ATTACHMENT (1)

TECHNICAL SPECIFICATION CHANGE

FIGURE 3.4-2a
CALVERT CLIFFS UNIT 1 HEATUP CURVE, 12 EFPY
REACTOR COOLANT SYSTEM PRESSURE TEMPERATURE LIMITS

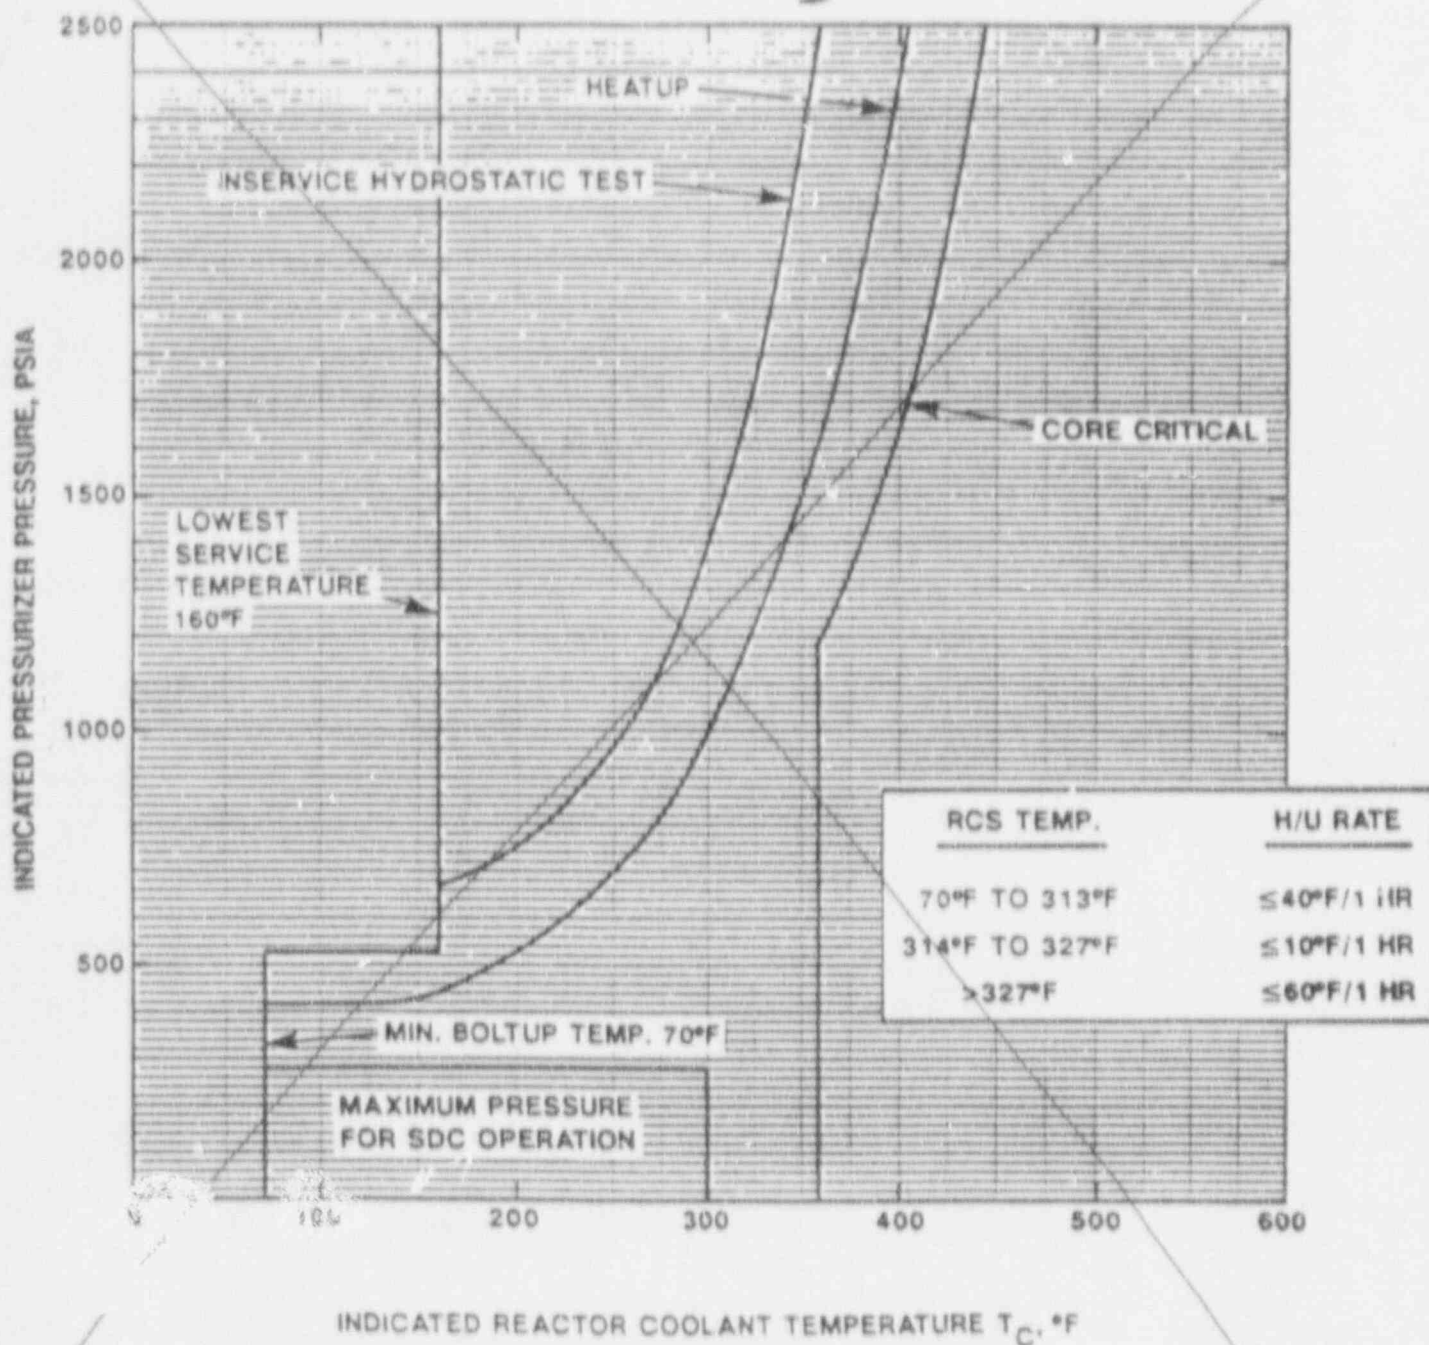
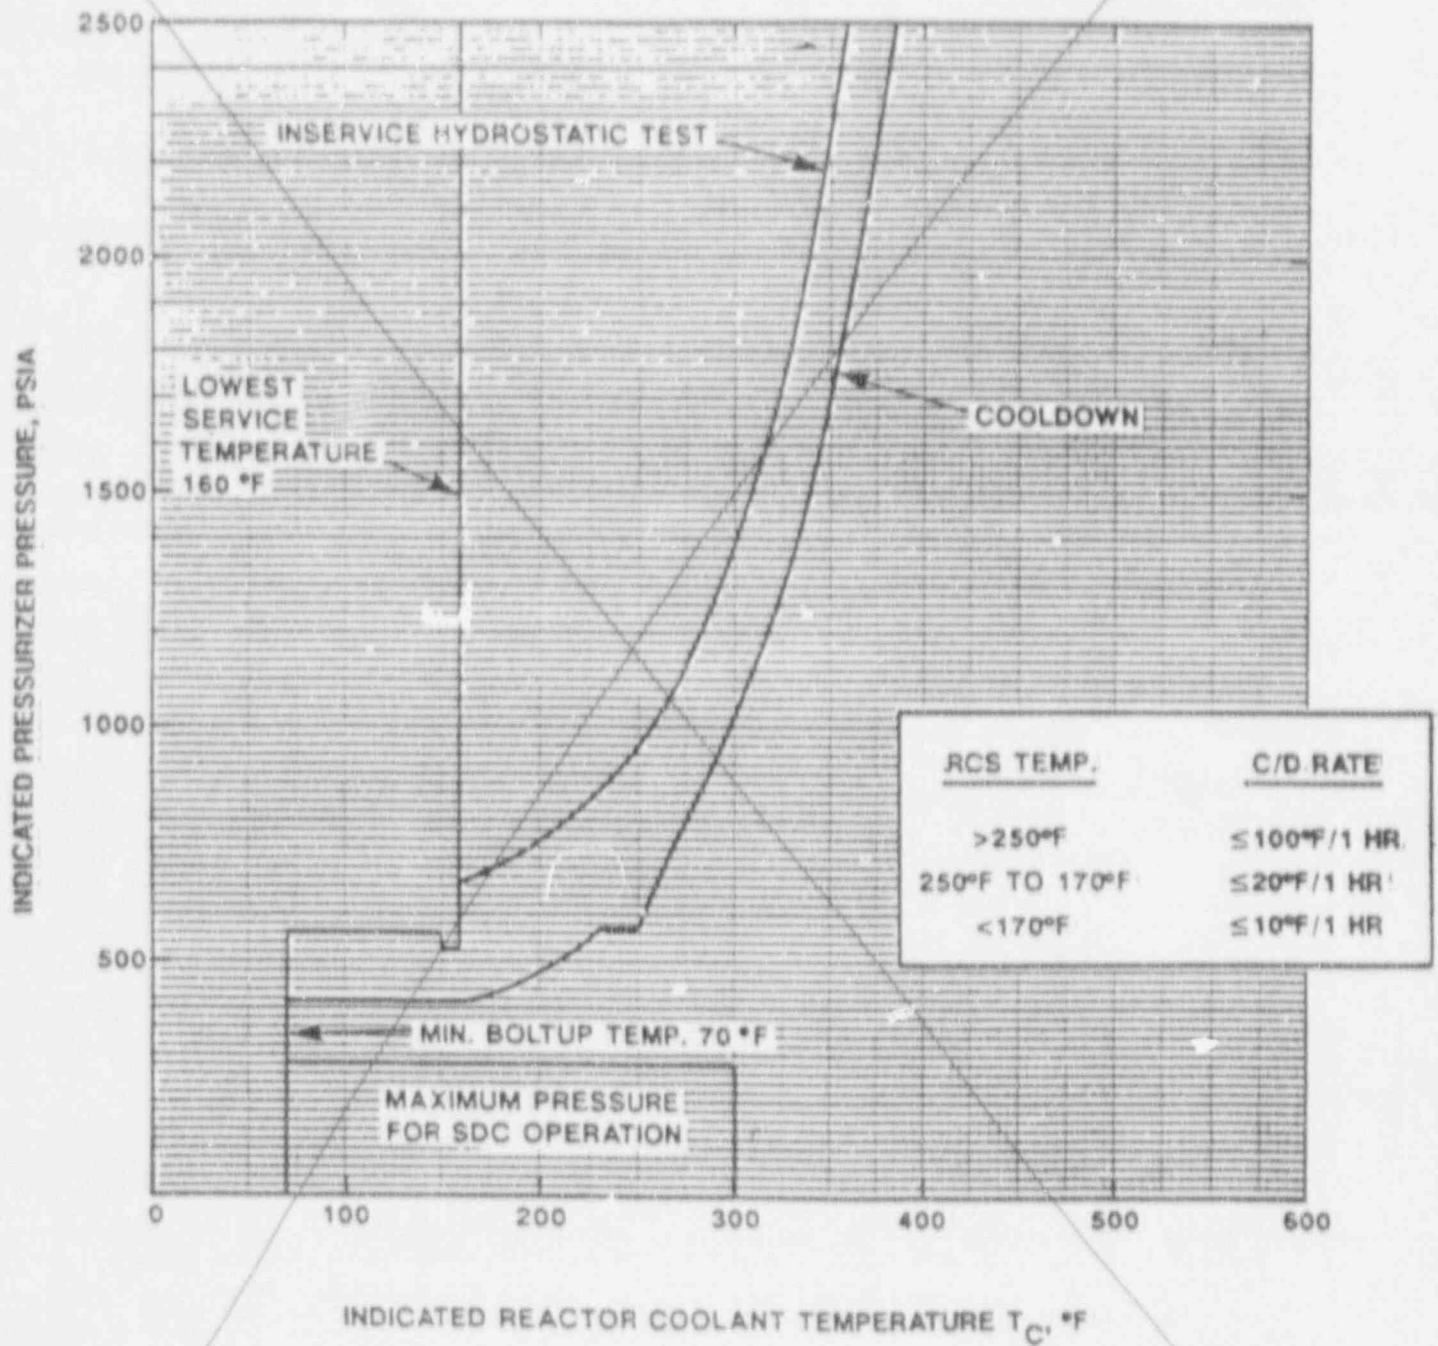
FIGURE 3.4-2a
 CALVERT CLIFFS UNIT 1 HEATUP CURVE
 REACTOR COOLANT SYSTEM PRESSURE TEMPERATURE LIMITS
 FOR FLUENCE $\leq 3.25 \times 10^{19}$ n/cm² AT THE INNER SURFACE OF THE REACTOR VESSEL

FIGURE 3.4-2b
CALVERT CLIFFS UNIT 1 COOLDOWN CURVE, 12 EPY
REACTOR COOLANT SYST 'M PRESSURE TEMPERATURE LIMITS

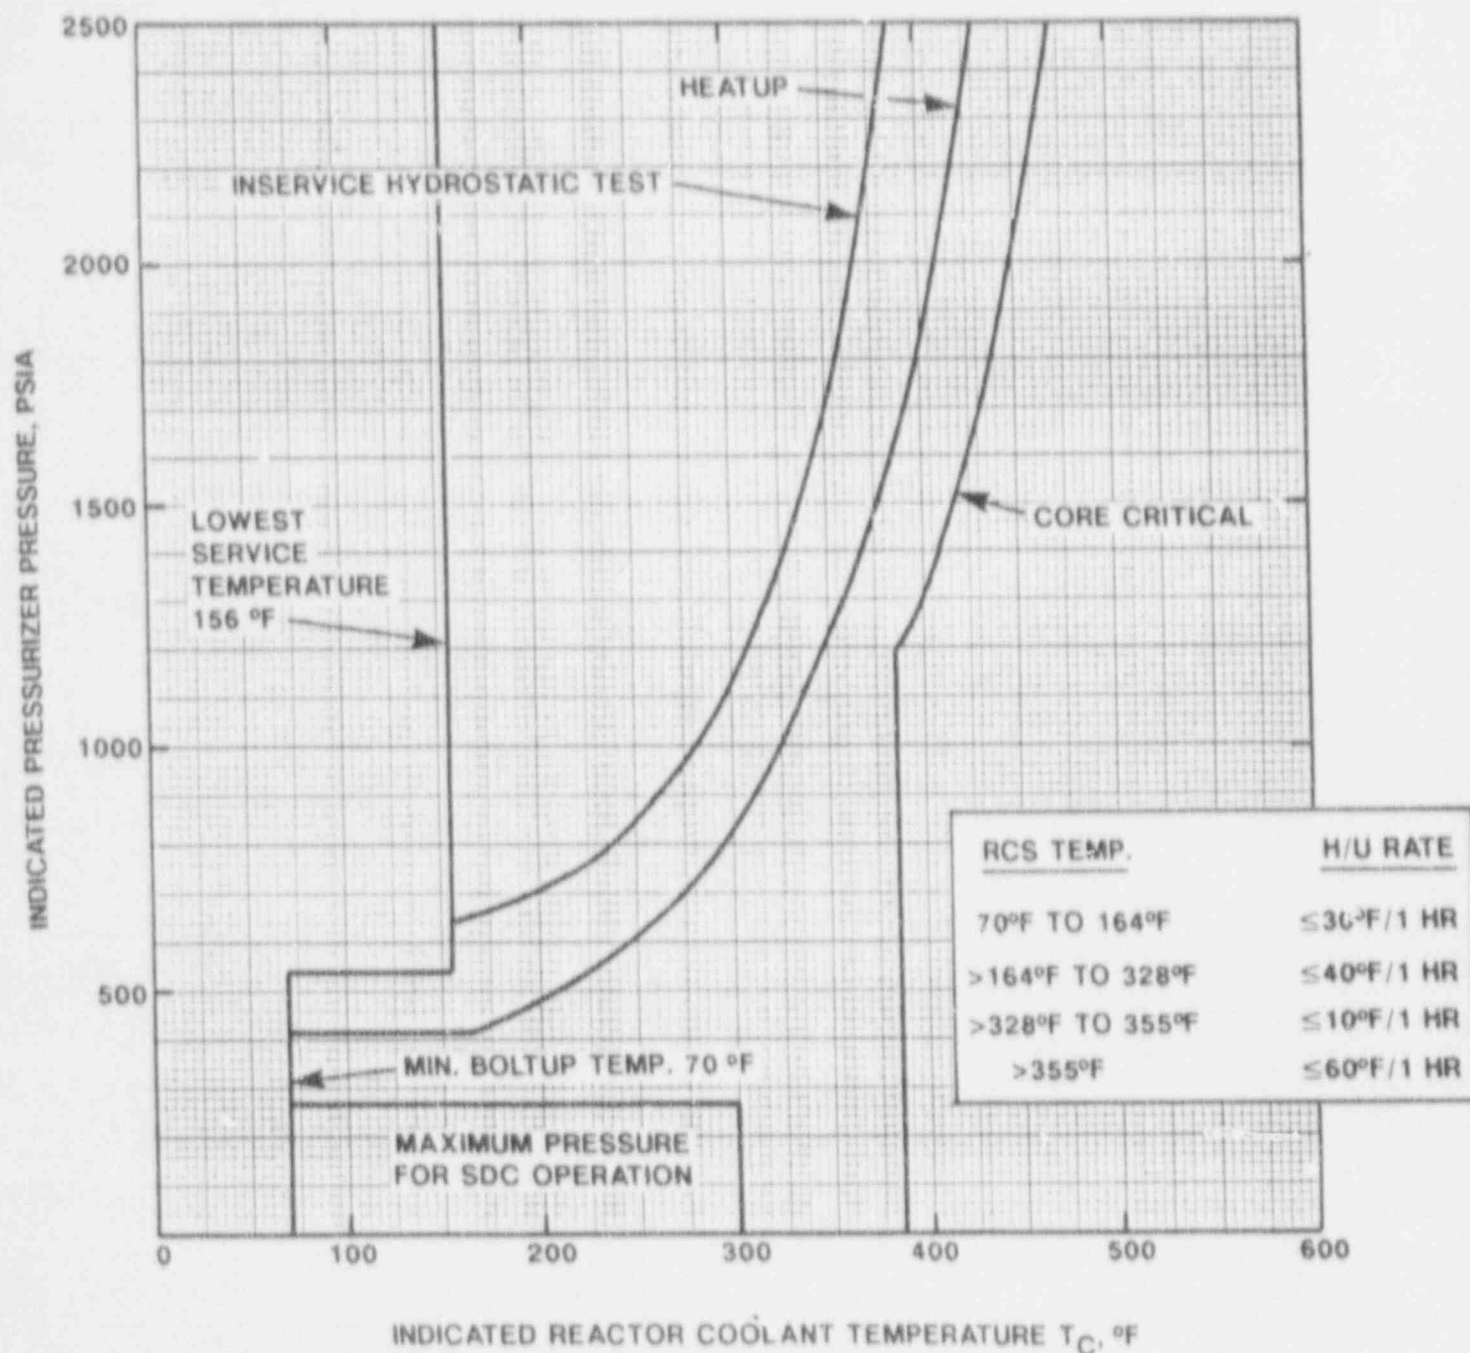
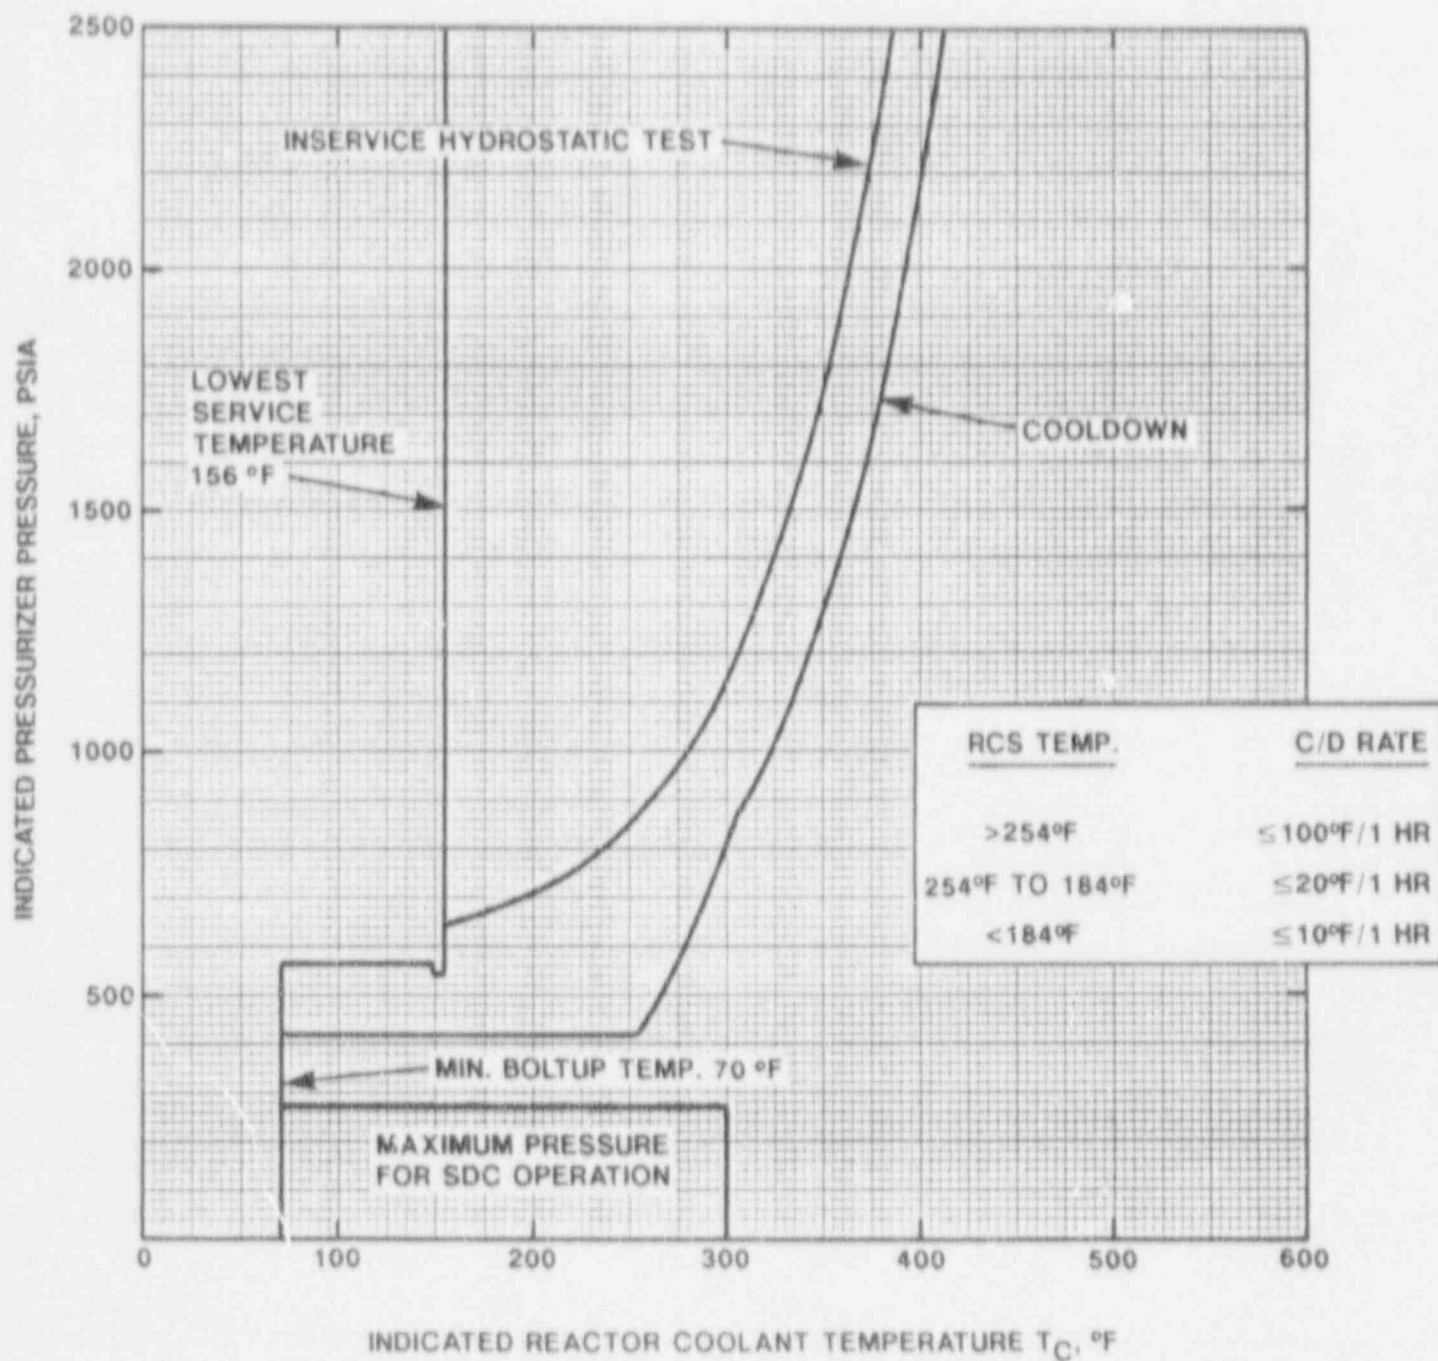
FIGURE 3.4-2b
 CALVERT CLIFFS UNIT 1 COOLDOWN CURVE
 REACTOR COOLANT SYSTEM PRESSURE TEMPERATURE LIMITS
 FOR FLUENCE $\leq 3.25 \times 10^{19}$ n/cm² AT THE INNER SURFACE OF THE REACTOR VESSEL
